SAN FRANCISCO PLANNING DEPARTMENT

Discretionary Review Abbreviated Analysis HEARING DATE: MAY 7, 2020

Date: April 30, 2020
Case No.: 2018-017375DRP-02
Project Address: 3627 Divisadero Street
Permit Application: 2018.1227.9267
Zoning: RH-3 [Residential House, Three-Family]
40-X Height and Bulk District
Block/Lot: 0919 / 001E
Project Sponsor: Micky Pucko
3627 Divisadero Street
San Francisco, CA 94123
Staff Contact: David Winslow – (415) 575-9159
david.winslow@sfgov.org
Recommendation: **Do Not Take DR and Approve**

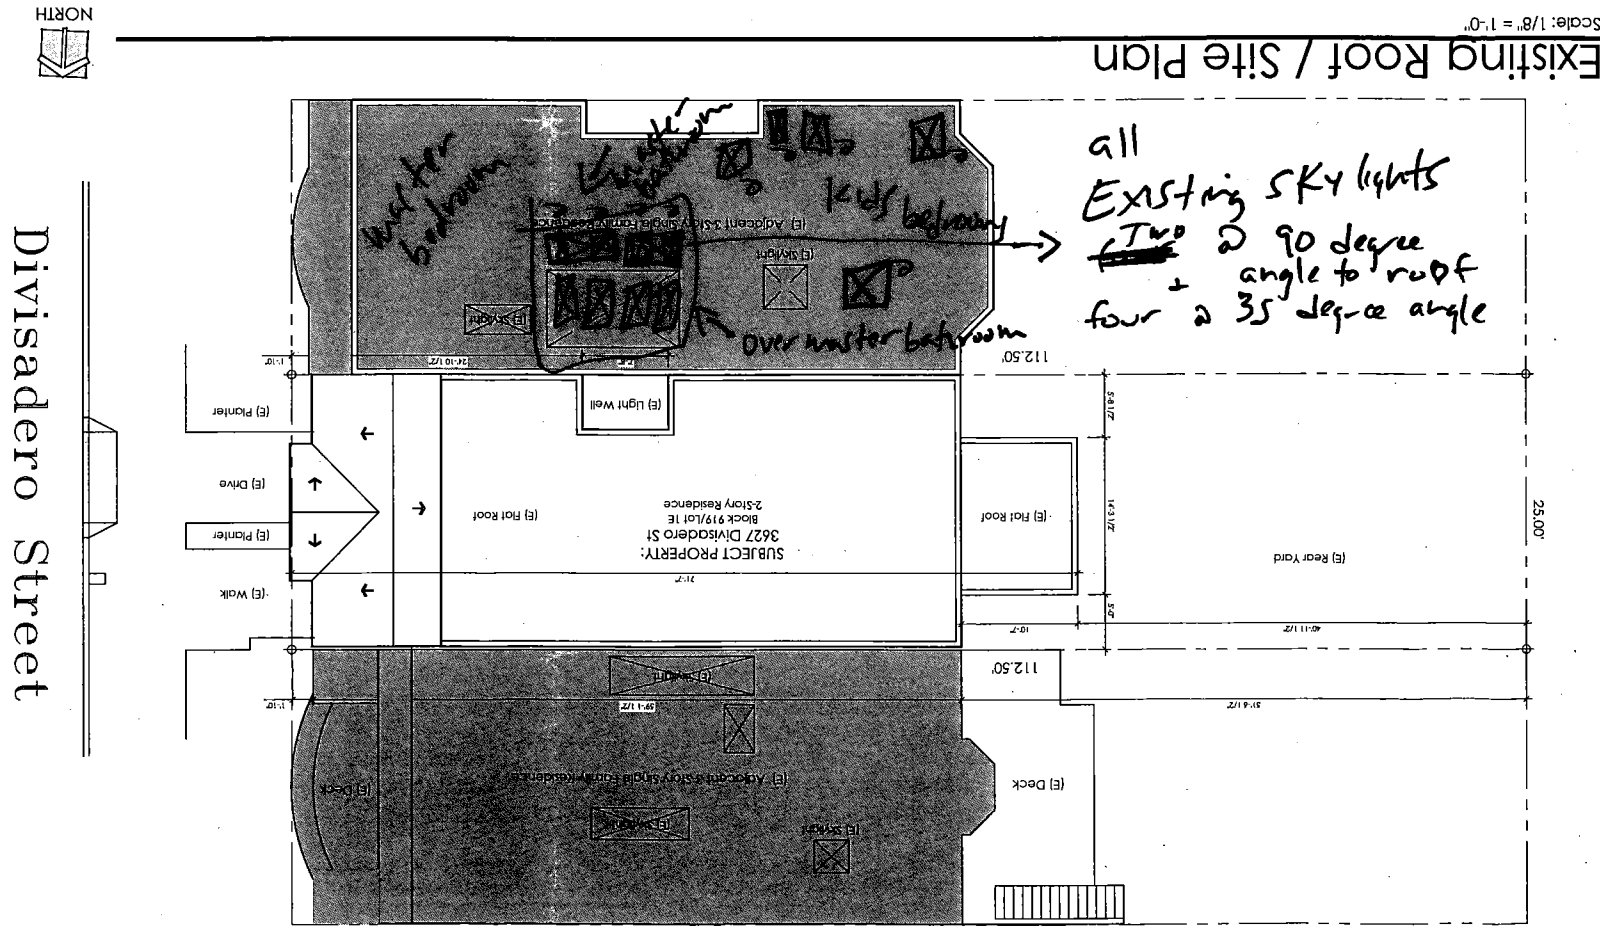
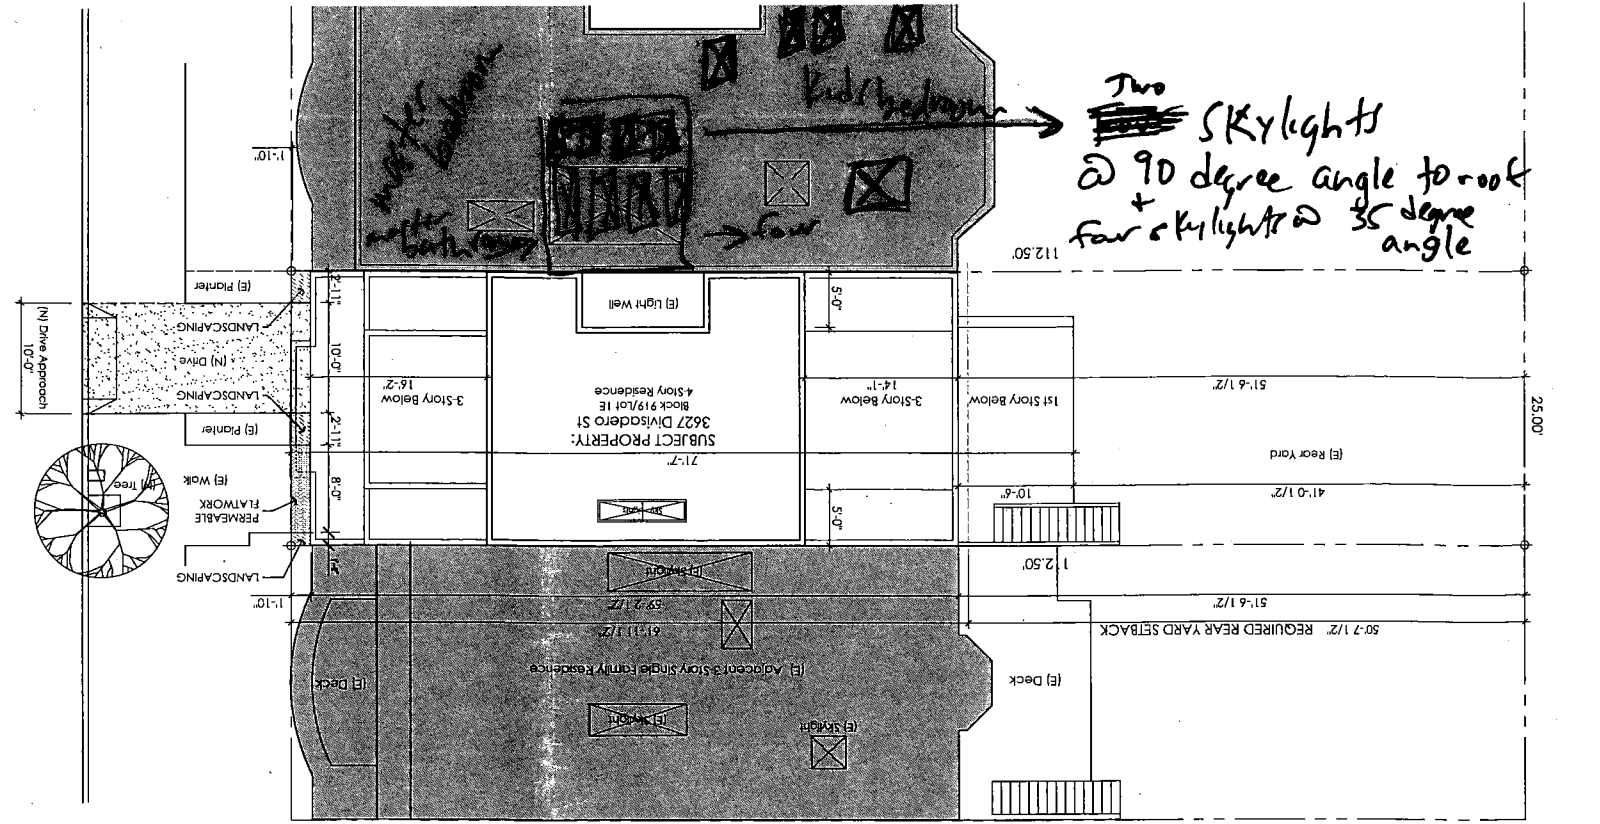
- Inaccurate neighboring property roof plans were submitted. The plans submitted to the City do not accurately depict the number of skylights we have on our roof (3621 Divisadero). We have 13 skylights on our third level, not 3. (See photos of roof and corrected roof plan on pages 4, 5 and 6.

- Compromised privacy due to fourth level decks. The fourth floor addition with approved outdoor space perimeters at both the front and rear of the building will look directly down into our master bathroom and bedroom living spaces. Although there are cable railings set back 5 feet from the north and south property lines, those could easily be removed after final inspection. The entire perimeter of the third story roof will have a fire-rated wall along our property line that can function as a deck guardrail. I am very concerned about visibility into our personal living spaces. All homes on this block are three levels. We all have either skylights, solar tubes and/or solar panels. We share the benefits of the sun and don't look into or onto each other's bedrooms and bathrooms. Row homes cannot build windows on property lines so skylights and solar tubes are a way to capture natural light. Moving forward with a fourth level home, as currently approved, allows a birds eye view into our third level master bathroom and bedroom spaces.

- Compromised privacy and increased noise/second hand smoke due to third story deck that extends full width of the house. Third level front deck located off the proposed project's new third floor living room is immediately adjacent to our master bedroom. The house immediate to the north of the proposed project also has bedrooms at the front of the third story. The Project Sponsor has notified me, in writing, "I just realized that our new front deck/living room is now next to yours and Katie's kids bedrooms. Any time we have people over, doors are open, people are smoking cigars, talking...noise will be going into your bedroom. Just giving you FYI." I would like a required set back at the sides of the deck or a permanent design buffer between the proposed project's outdoor third level living room front deck and both adjacent neighbors bedrooms.

North-South Building Section

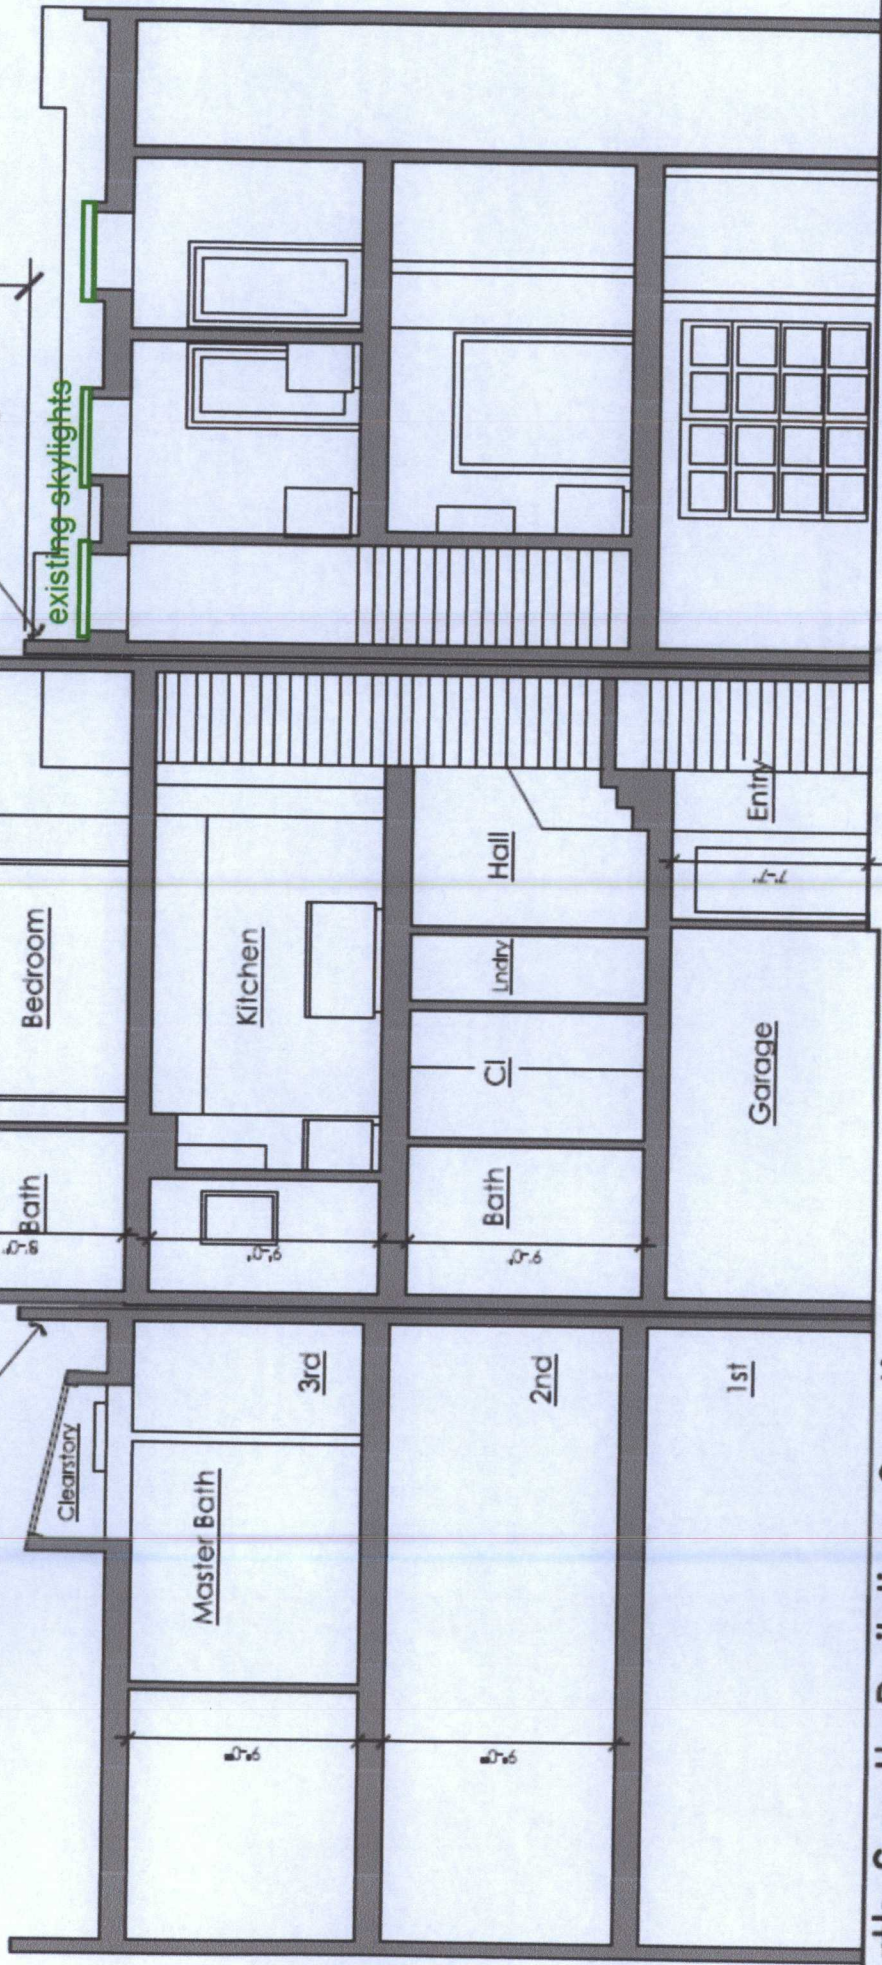
- **The plans contain significant omissions that misrepresent the scale, visibility, and impacts of the 4th story.**
 - The total height of the building along the north property line is understated because the plans omit the parapet required by the 4th story skylight. (See DR, pp. 8-13) The skylight is within five feet of the property line, and would require a fire-rated parapet at least 30" taller than the top of the skylight. Our roof is approximately 30'-2" high, and the parapet would increase the Subject Property to approximately 41' tall (38'-5" + 30") along our property line, with no setback whatsoever. During the winter months, the 11' height difference between the Subject Property and our roof would create a shadow extending at least 20', shading approximately 80% of our roof midday. (See, e.g., DR pp 14-15)

- Remove the 4th story skylight, or require any 4th story skylight to be more than 5'-0" from the north property line. This would eliminate the need for a fire-rated parapet along our shared property line, adjacent to our large skylight/lightwell.

Meneghetti's Request #2, pg. 3 DR filing

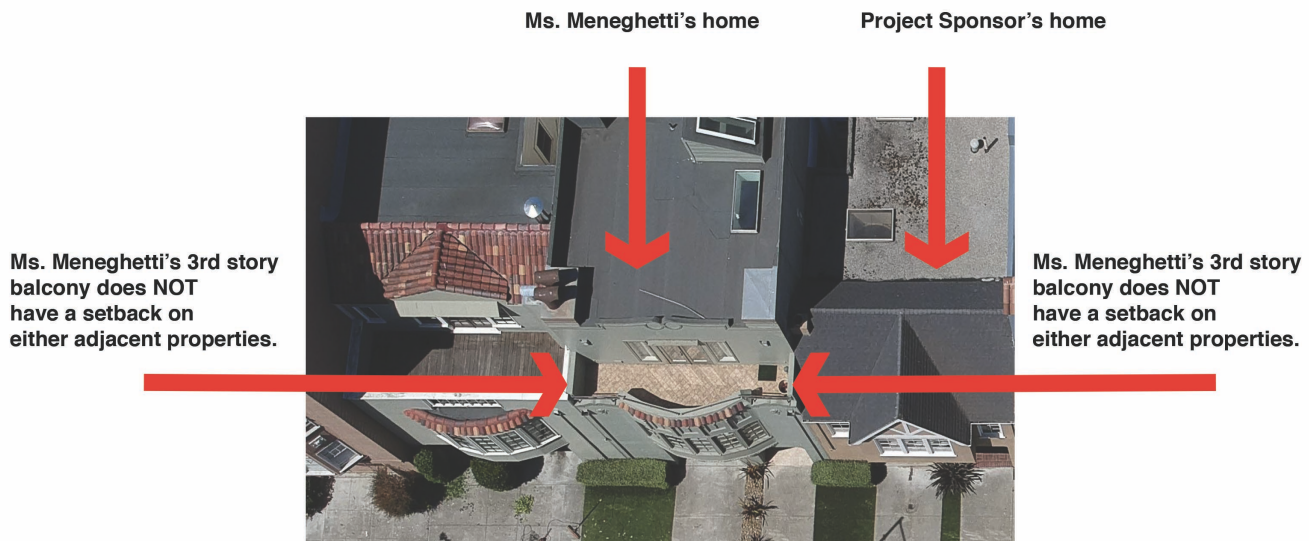
I request three feet setback from the property line along my third level bedroom deck. The setback/buffers could be similar to the ones at the front third story deck at 3633 Divisadero or 3639 Divisadero. I have been informed by the Project Sponsor that there will be cigar smoke and noise going into my bedroom, so I would like a reasonable setback which would result in less smoke and noise in our sleeping space. The proposed project has their living room space on the bedroom level of all the other homes on the block which is fine, but I request a permanent buffer to minimize noise and second hand smoke concerns and allow me to be able to open my windows for fresh air.

Additional Proposed Proposed concession #1 to preserve Meneghetti's Privacy: Pursuant to the RDG, Sponsors will support Ms. Meneghetti's **installation of privacy screens and/or privacy landscape** on her deck in order to preserve privacy and buffer any potential noise. **In every conversation with Ms. Meneghetti,** Sponsor offered to install privacy landscape on her 3rd story front deck to further shield any privacy and noise concerns. (See *below*)

Miller's Request #1 – pg. 5 DR filing

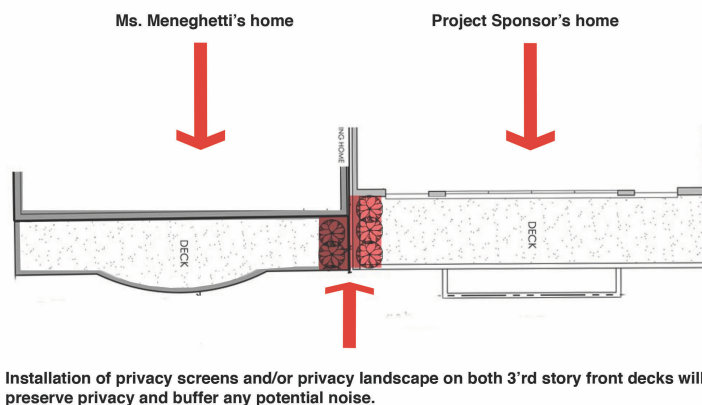
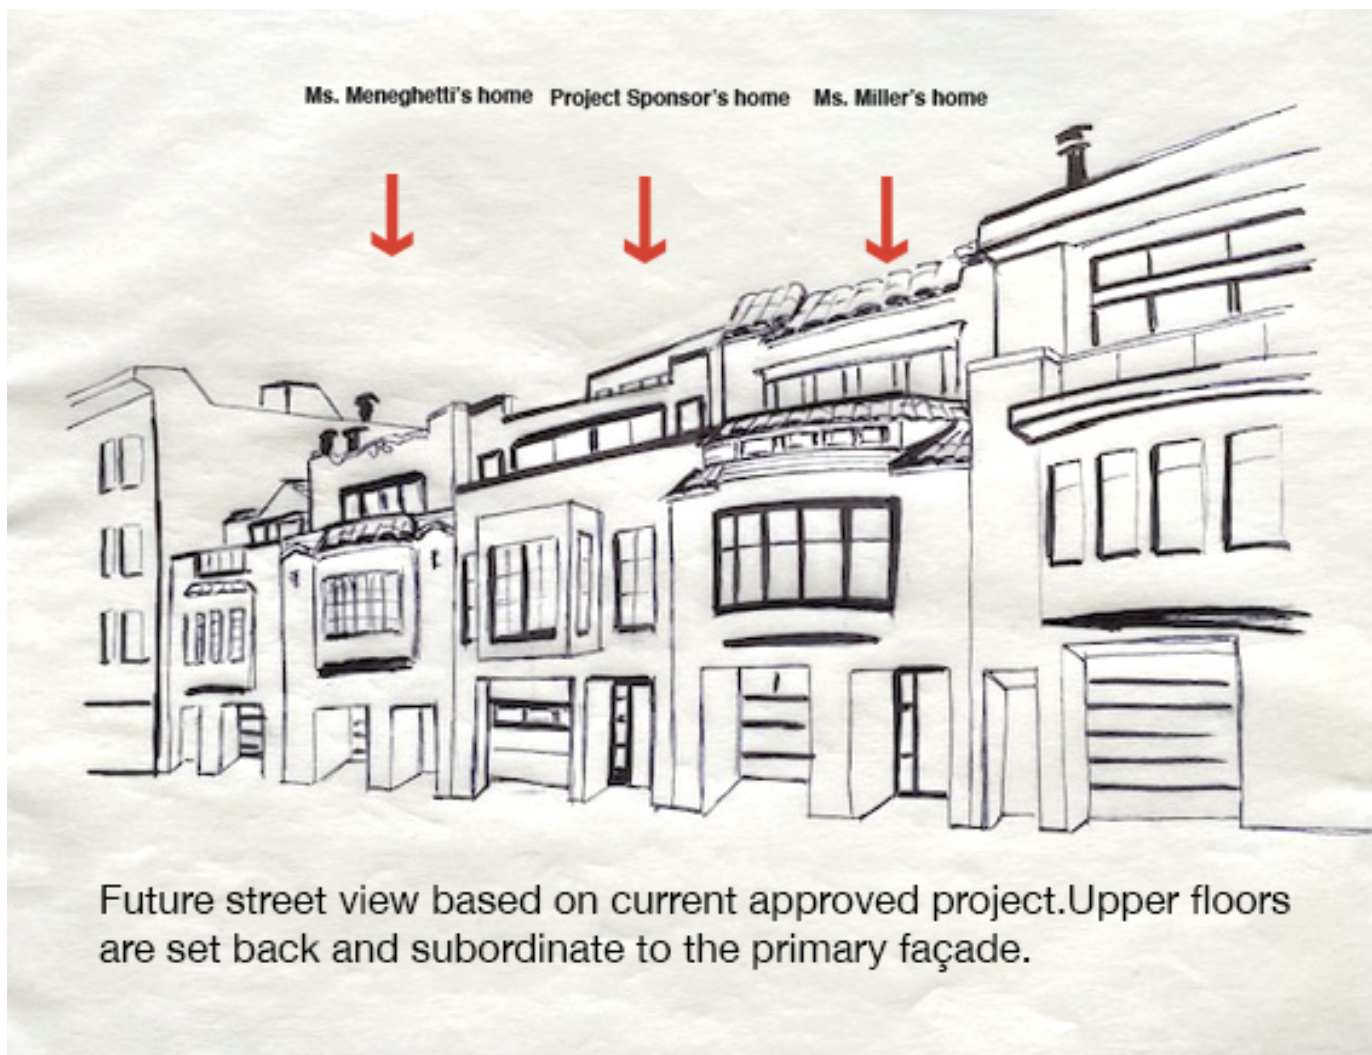
Require the 4th story to be set back at least 20'-0" feet from the front wall, consistent with RDAT's August 2019 request.

Project Sponsor's Response:

Ms. Miller seeks further modifications to the fourth story setback to conform with the RDG; however, Sponsor has already made additional revisions to comply with RDAT's and RDG's instructions. **RDAT has confirmed that no additional changes are necessary and that the Project complies with the guidelines' recommendations.**
